Access Design Assessment Report
Development Application

Budawang School
Milton NSW 2538

Project: Budawang School
 Milton NSW 2538
 Document Type: Access Design Assessment Report
 Our Reference: P220_441-3 (ACCESS) FMR

BLOCK A PLAN

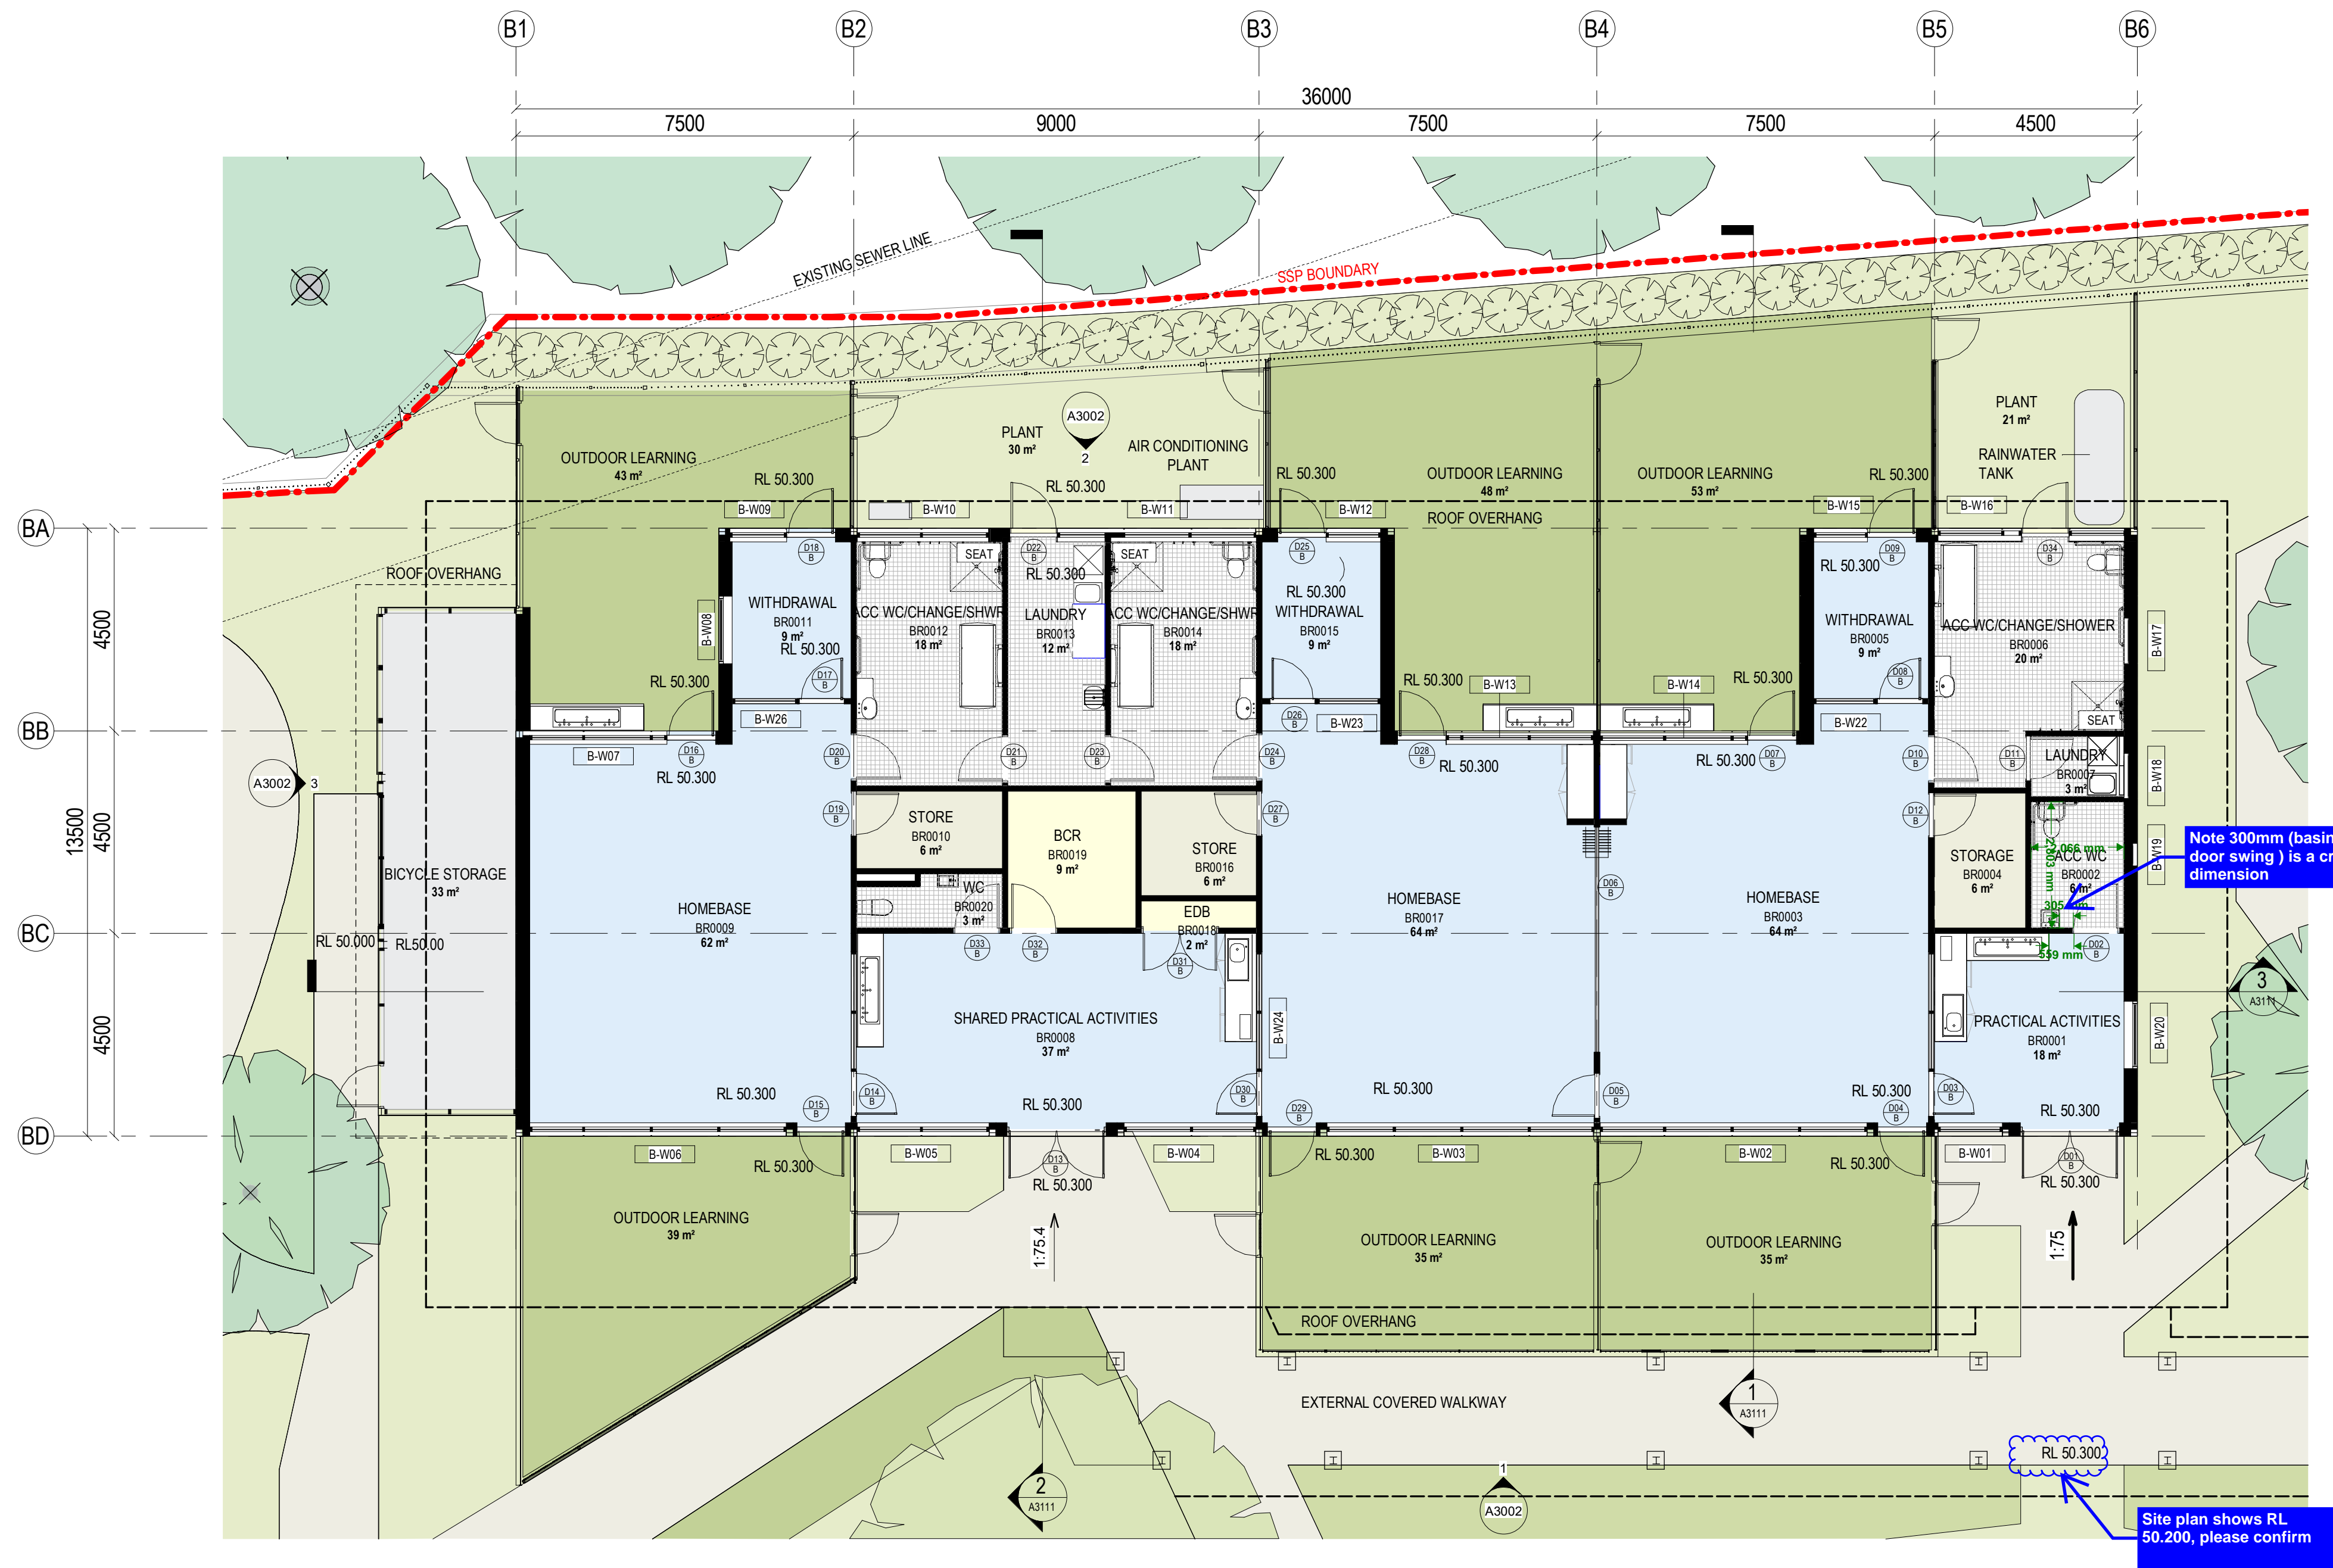
DESCRIPTION	COMMENT	RESOLUTION
Bifold doors	<p>Bifold doors are proposed to be provided, whereby in some instances access between different rooms being solely via bifold doors. This is referent to the following locations –</p> <ul style="list-style-type: none"> Block A1 – between Staff Lounge and Staff Study; Block A2 – between Kitchenette and Life Skills. 	<p>Bi-fold doors are not accepted in the accessway.</p> <ul style="list-style-type: none"> Option 1 - one of the door leaves to be capable of being operated as a by-pass door achieving min. 850mm clear opening and circulation spaces; Option 2 - include a hinged door adjacent the bi-fold door with min. 850mm clear opening and circulation spaces;

DESCRIPTION	COMMENT	RESOLUTION
		<ul style="list-style-type: none"> Option 3 – pursue a performance-based solution to justify the current design.
Doors – clear opening	Reduced clear opening width is achieved at the door serving the Hydrotherapy building (D02 – D).	<p>Doors will be required to achieve a minimum 850mm clear opening width. This generally requires a minimum 920mm door leaf.</p> <p>Where double doors are used, at least the active leaf shall achieve a min.850mm clear opening width.</p>
Door – circulation space	The door from the Life Skills room (A2R0011) is provided with nil latch-side circulation space on the external side due to the 1:20 walkway located directly adjacent to the subject door.	<p>Clarify if the subject door is proposed being for egress only.</p> <p>If proposed as an entry to the Life Skills room, the latch-side circulation space to the external side shall be not steeper than 1:40.</p>

DESCRIPTION	COMMENT	RESOLUTION
Transfer side	<p>A total seven (7) accessible sanitary compartments for students are proposed as follows –</p> <ul style="list-style-type: none"> Block A1 (A1R0004) – RH; Block A2 (A2R0002) – RH; Block A2 (A2R0018) – LH; Block B (BR0002) – RH; Block C (CR0011) – LH; Block D – Female (DR0005) – LH; Block D – Male (DR0015) – RH. <p>Moreover, two (2) accessible sanitary compartments for staff are provided, being –</p> <ul style="list-style-type: none"> Block A1 (A1R0012) – LH; Block D (DR0006) – RH. 	Refer to comments below for further guidance.
Unisex facilities	Concern is raised whereby 2 x accessible WCs in the Hydrotherapy building are located within an area reserved of one sex only, being within the Male and Female Change rooms.	Clause F2.4(f) requires that an accessible unisex sanitary facility must be located so it can be entered without crossing an area reserved for one sex only.

DESCRIPTION	COMMENT	RESOLUTION
Circulation space	The basin obstructs the required circulation spaces within the ambulant WCs in Block A1.	A min. 900x900mm clearance shall be achieved forward of the toilet pan and forward of the door.
Staff WC	A WC for use by staff is proposed (A1R0011), which is not currently proposed as an ambulant WC.	The subject WC shall be provided as an ambulant WC and shall be designed in accordance with Clause 16 of AS1428.1-2009.
Design detail	Detailed wet area drawings have not yet been provided.	Level of detail provided is suitable for this stage – as design progresses, provide details for review and comments.
